SUBJECT : Hyundai ImageQuest Co., Ltd.
FCC ID: PJIL17A0D083
Class II permissive change
Orig. Grant Date: June 17, 2003

Transmitted herewith, on behalf of Hyundai ImageQuest Co., Ltd. is an application for a Class II Permissive Change Certification of the following 17-inch LCD Monitor:

FCC ID : PJIL17A0D083
Model/Type : L17T/ L17A0D083

• Solution for EMI

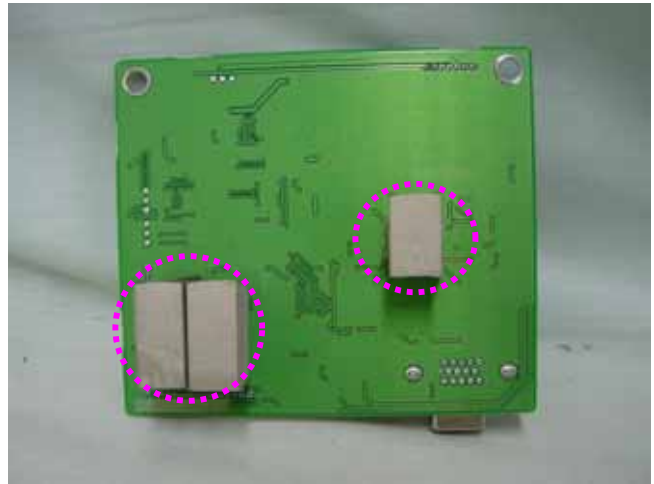
1. Attach a gasket on the Main Board and Main Frame to contact a LCD panel

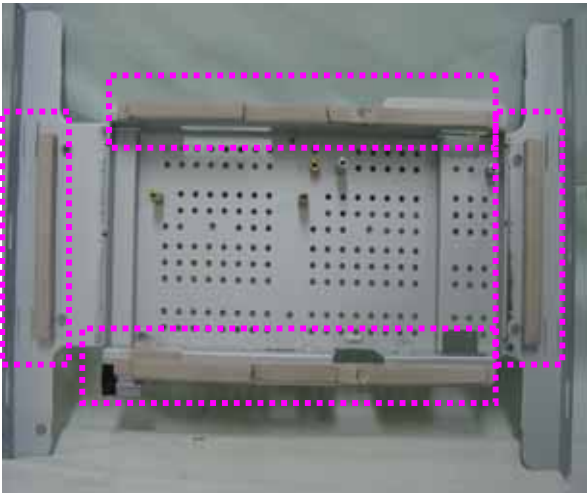
2. Attach a gasket on the Audio PCB to contact a stand

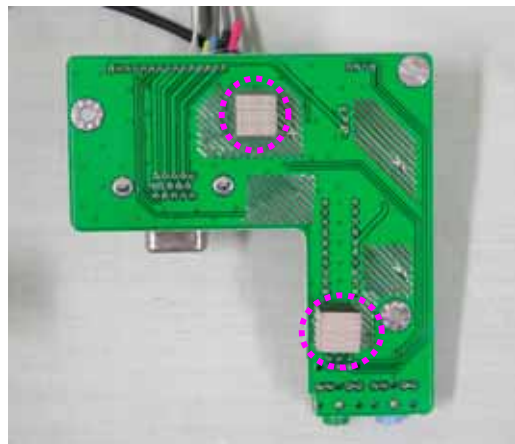
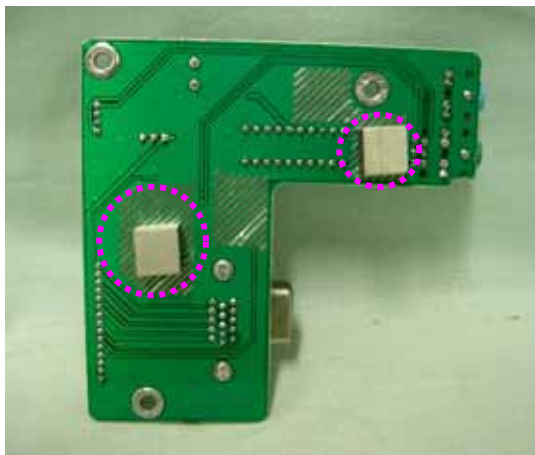
3. Attach a gasket and aluminum foil between Main Frame and LCD panel

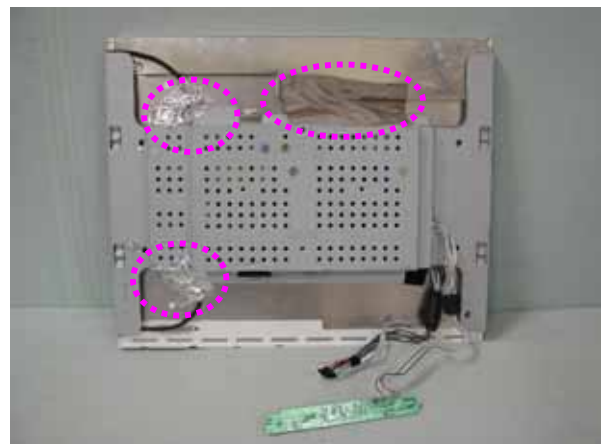
4. Apply a ferrite Core to the Audio Cable, Multi cable and OSD board signal cable
